### Proposed Revisions to a Standard Plans Index

Index Number: 641-010

Index Title:  
Concrete Poles

**Summary of the changes:**

SHEET  
1 of 10 11

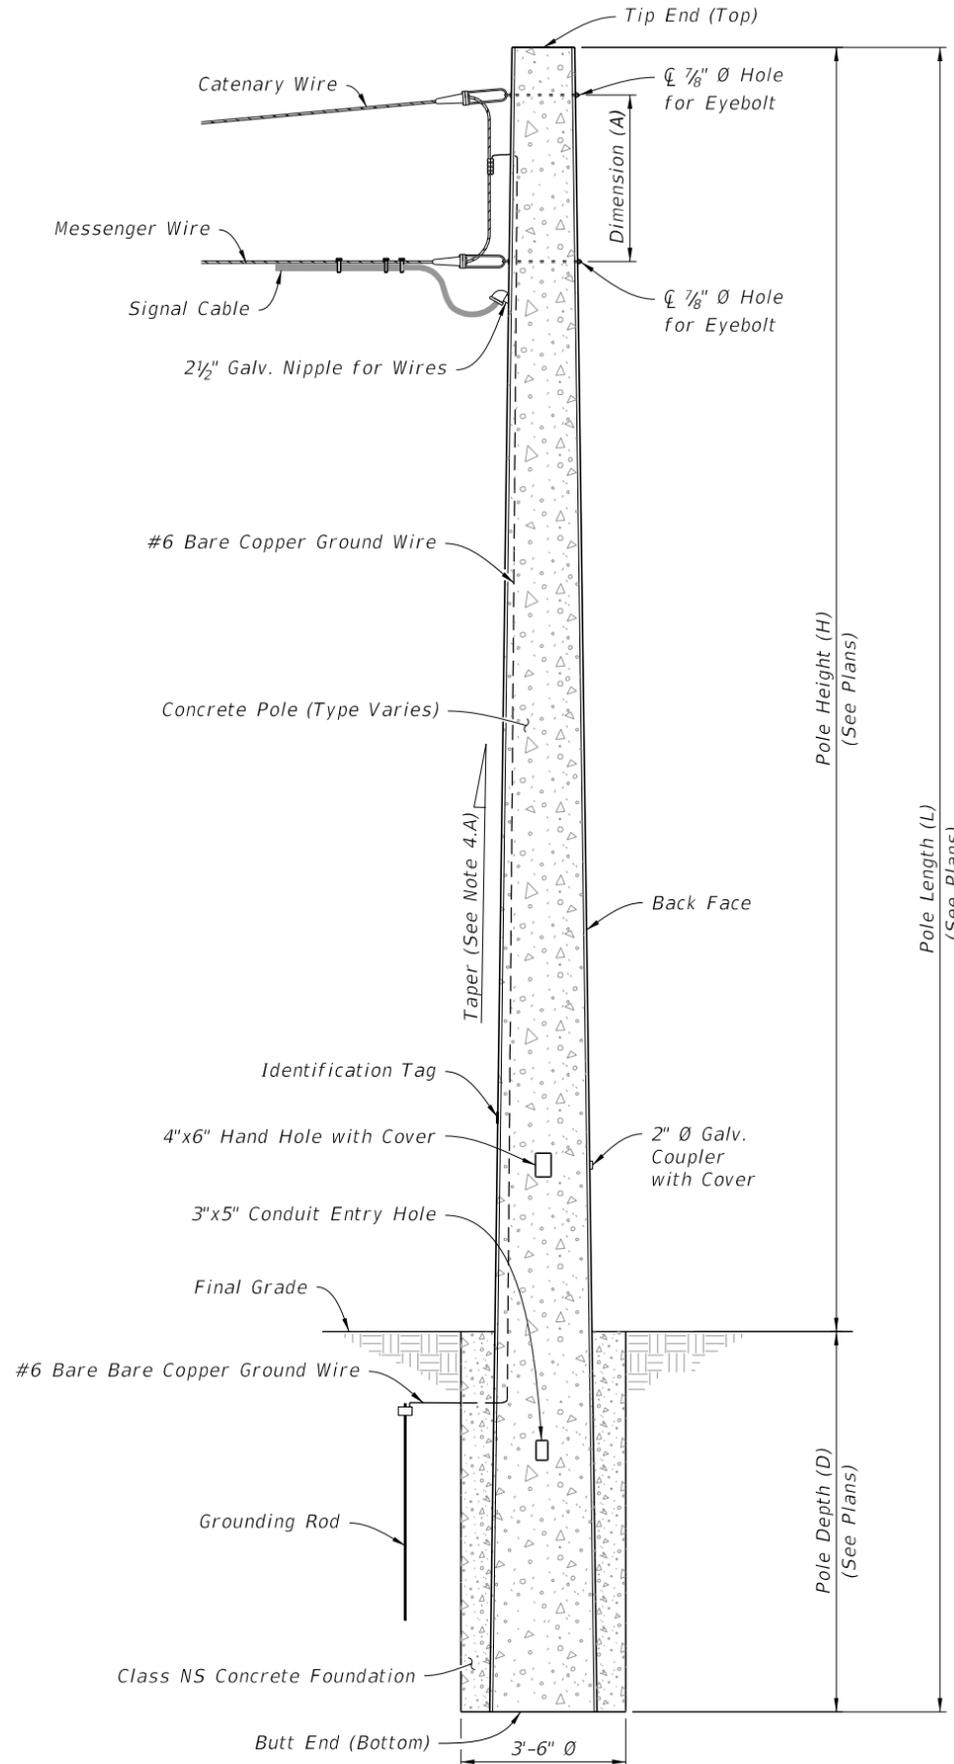
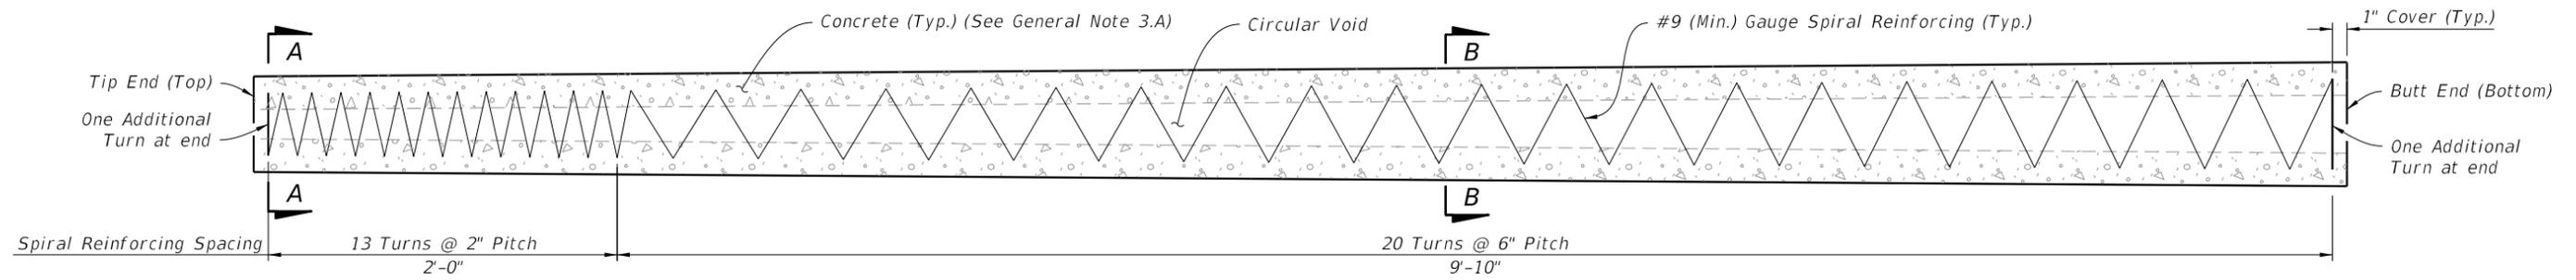
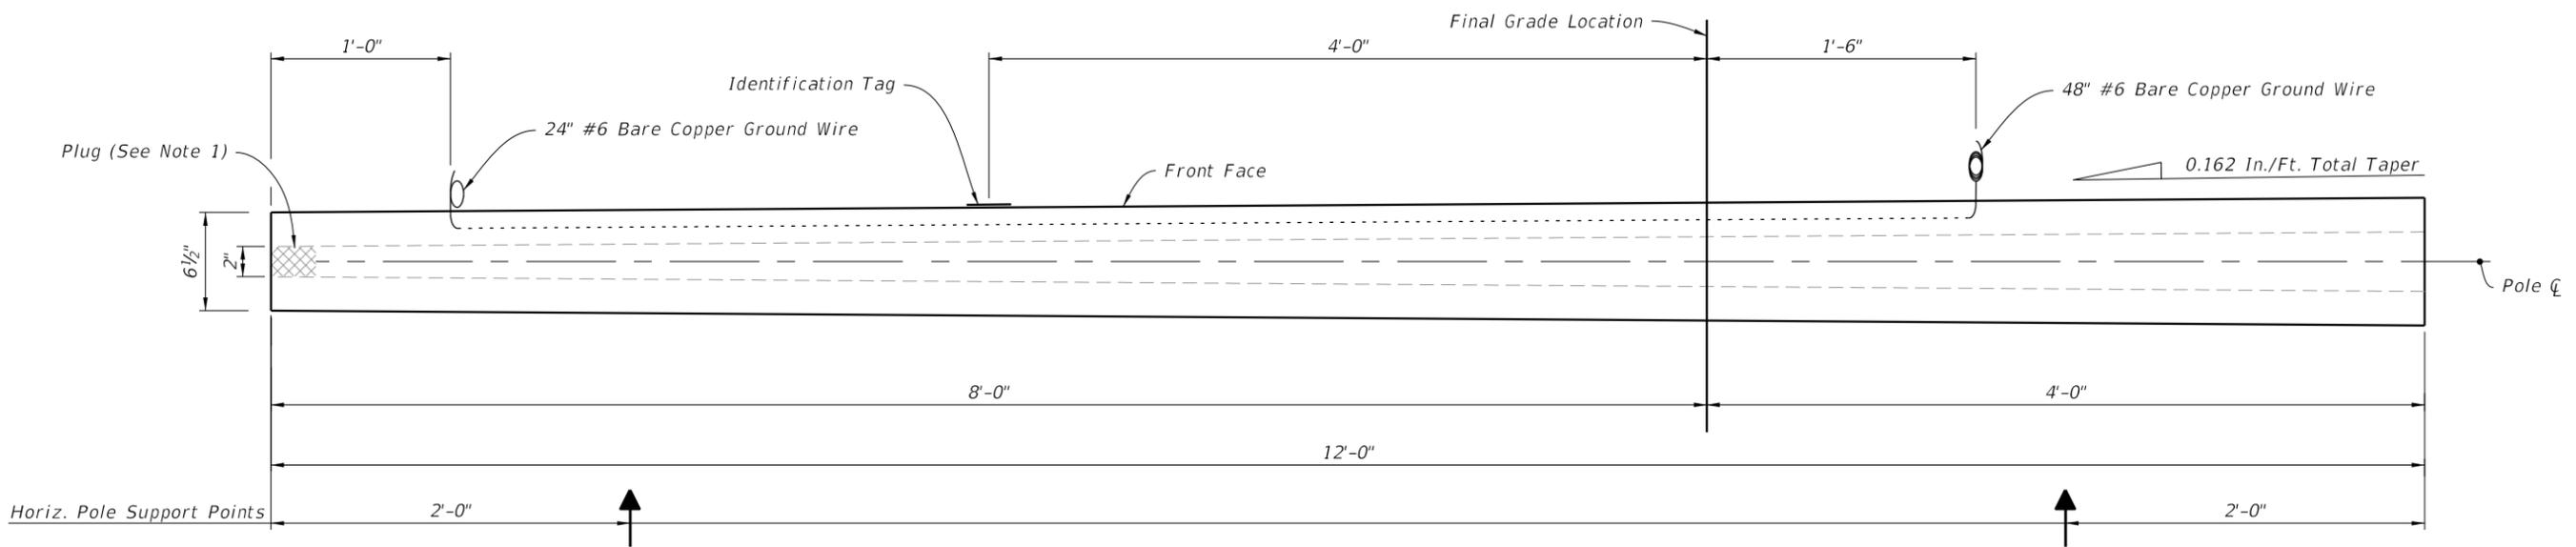
Sheet 1: Change Note 3.A reference to Class V Special to Class V.

- A. Concrete: Deleted *Class V Special with 4 ksi minimum strength at transfer or Class VI with 6.5 ksi minimum strength at transfer Specification 641*
- B. Prestress Strands & Spiral Reinforcing: *Specification 641*
- C. Hand and coupler cover plates: *Non-corrosive material*
- D. Screws: *Round headed, chrome plated*

SMO has proposed to remove Class V Special Concrete as an option from the Standard Specifications and therefore the Standard Plans must be updated.

SERVICE POLE - TYPE 11D (16 Ft.)

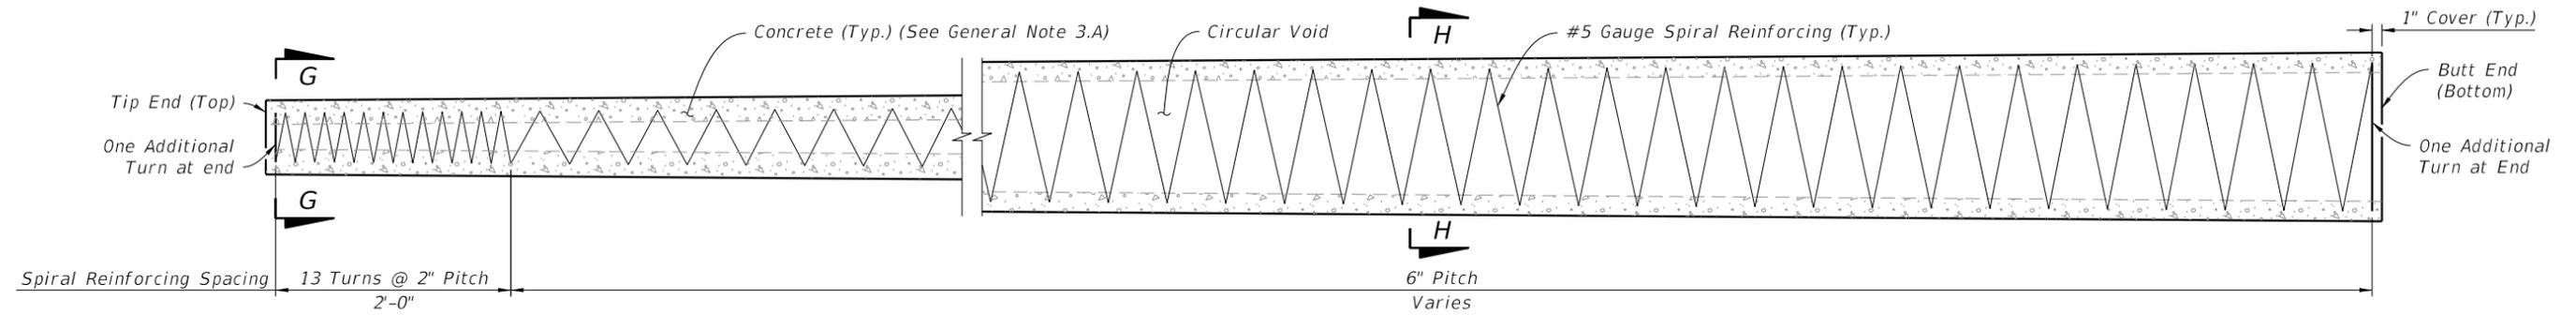
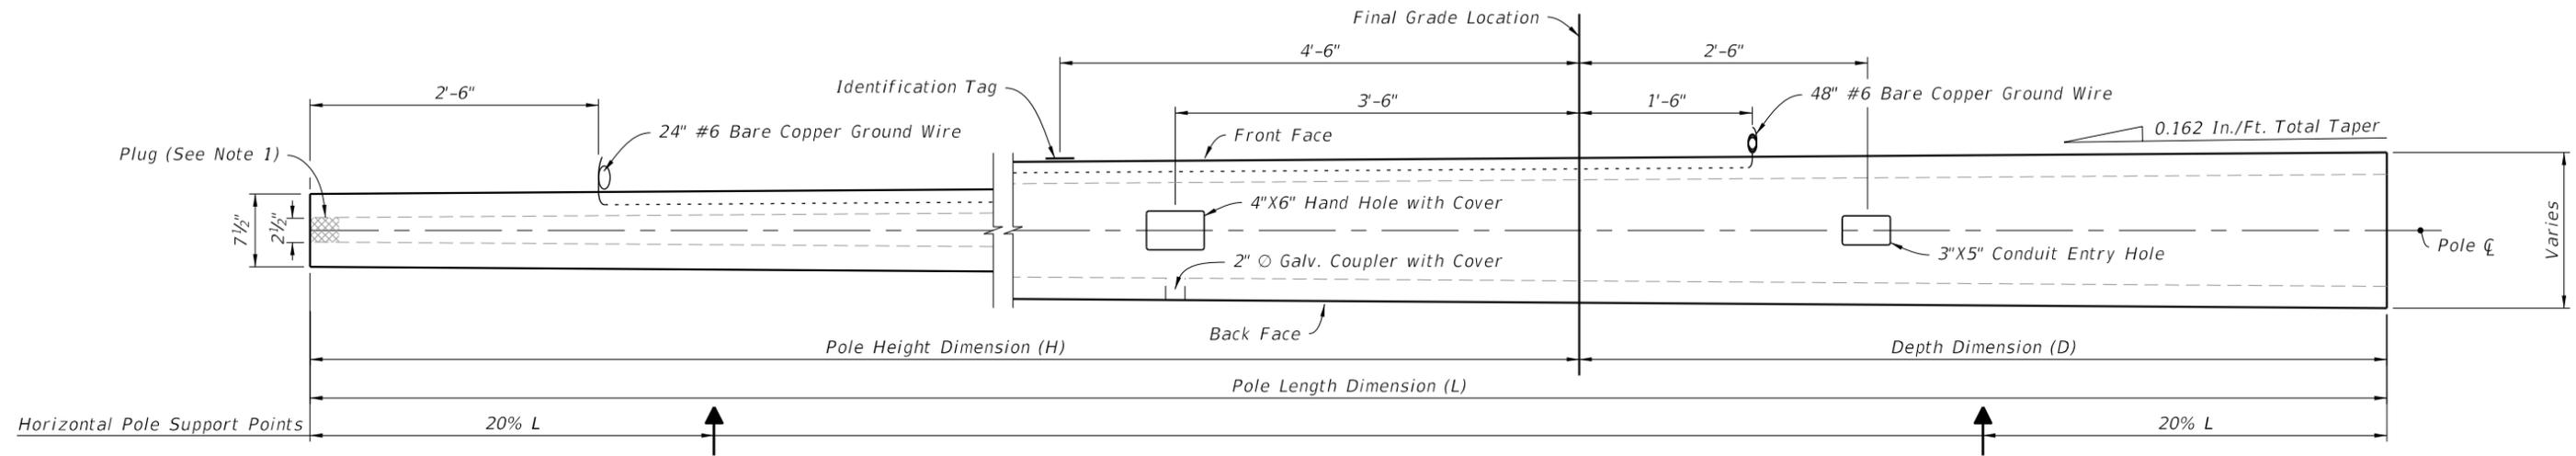
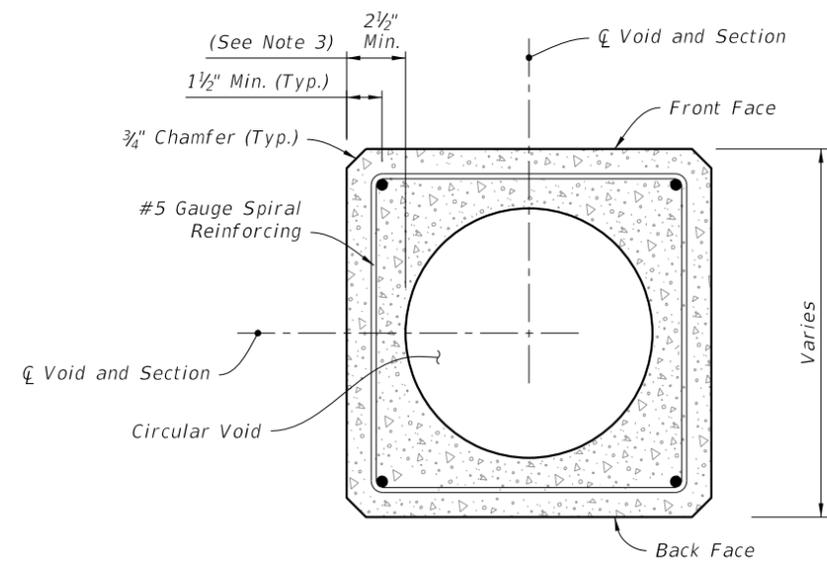
Sheet 5: Added new sheet for a new 16 ft pole version P-IID.

NEW SHEET 5

This 16-foot pole was requested by Districts to accommodate project-specific service point designs. Electrical service point details for a 16-foot pole are under consideration for a future Standard Plans publication.
